"LETTER OF TRANSMITTAL AND ERRATA SHEETS FOR FINAL ACTION MEMORANDA
FOR POTENTIAL SOURCES OF CONTAMINATION 32, 45 AND 46 NAS CECIL FIELD FL"

6/1/2000

Subject: Errata Sheets for Final Action Memoranda – PSCs 32, 45 and 46
Naval Air Station Cecil Field
Jacksonville, Florida

CONTRACT NUMBER	
D039	
APPROVED BY	DATE
APPROVED BY	DATE
DRAWING NO.	REV
FIGURE E-2	0

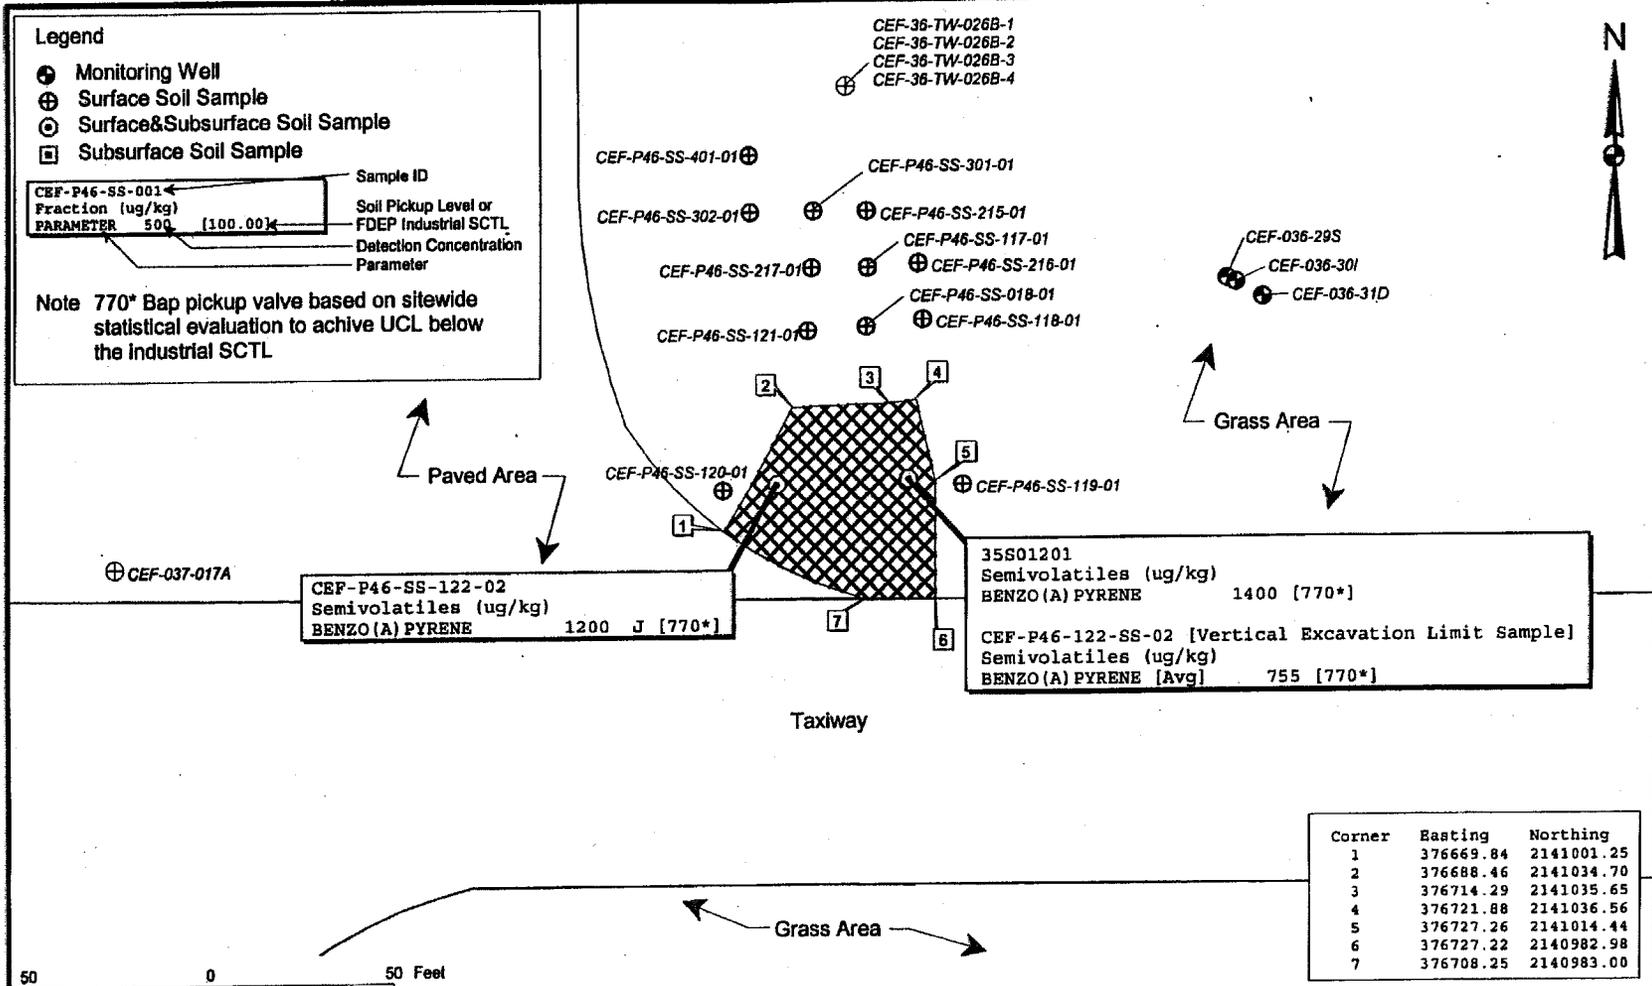
Please find attached one copy each of the Errata Sheets for Final Action Memoranda for PSC 32, PSC 45, and PSC 46. Copies have also been distributed to the Partnering Team Members as indicated below. Some of the BCT comments on the Action Memorandum were not included in the documents submitted on May 26, 2000. Those changes have been incorporated into the attached sheets. Also included are the excavation drawings that have been revised to include the coordinates of the corners of the excavations.

PSC 46 – Page 8
Figures E-2 through E-5
